UNITED STATES PATENT AND TRADEMARK OFFICE

Office Action Summary	Application No. 10/538,554	Applicant(s) KOLLMANN ET AL.	
	Examiner Kristie A. Mahone	Art Unit 3751

DETAILED ACTION

Figure A. Gransow, et al Figure 4.

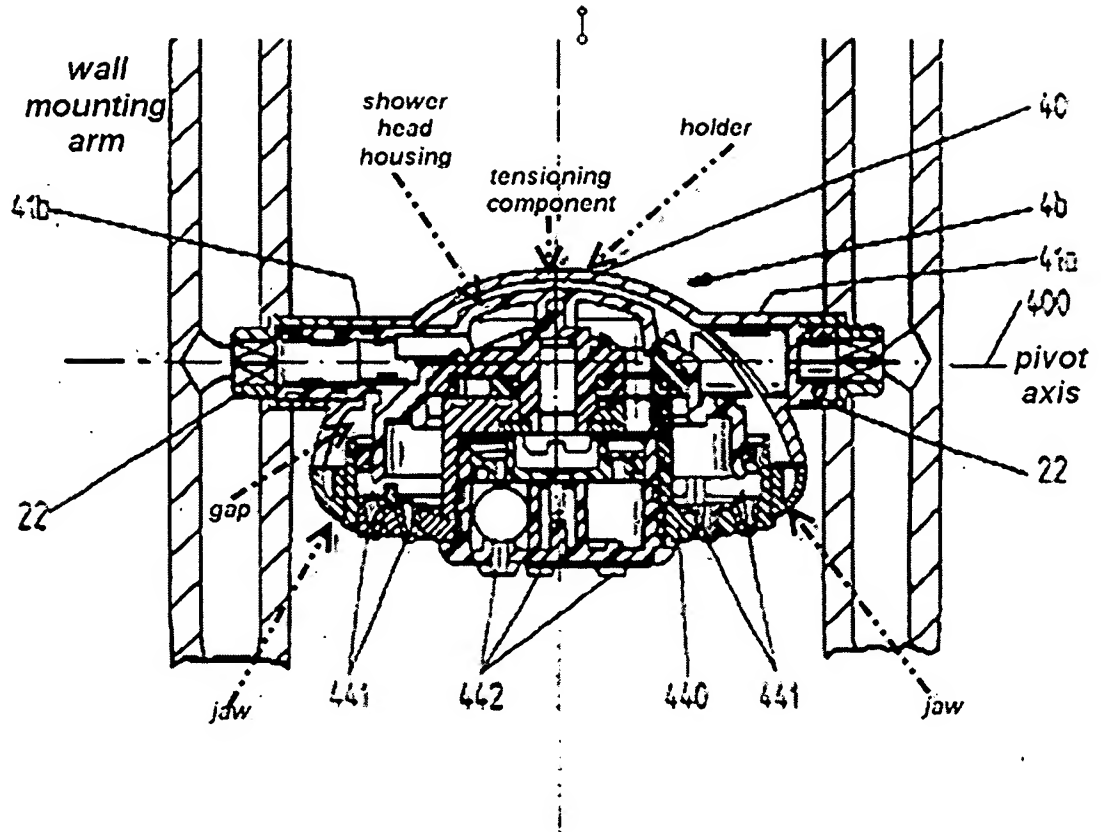
With respect to claims 11-14, 19, and 20, reference is made to Figure A. As schematically shown, that the pivot axis of the holder (400) intersects a housing of the showerhead, near a centroid thereof (Fig. 4). The holder for the shower head is configured to engage a location on a housing of the showerhead (as at an outer perimeter thereof) provided for holding it that is not recognizable as such (based on its shape at that location) and acts by means of a "interference fit" in a withdrawal, or insertion direction. The holder engages the housing of the shower head a two locations on its surface which are approximately opposite and diametrically opposed.

Regarding claims 18, 21-24, and 31, the shower head, shower head housing, holder, tensioning component, and jaws are labeled in Figure A. The jaws on the holder of the shower head are tensioned toward one another while the shower head is inserted. Further note that contact between the tension component and shower head housing takes place over an extended area.

Regarding claim 30, the axis (400) about which the holder rotates intersects the showerhead near a centroid thereof (Fig. 4).
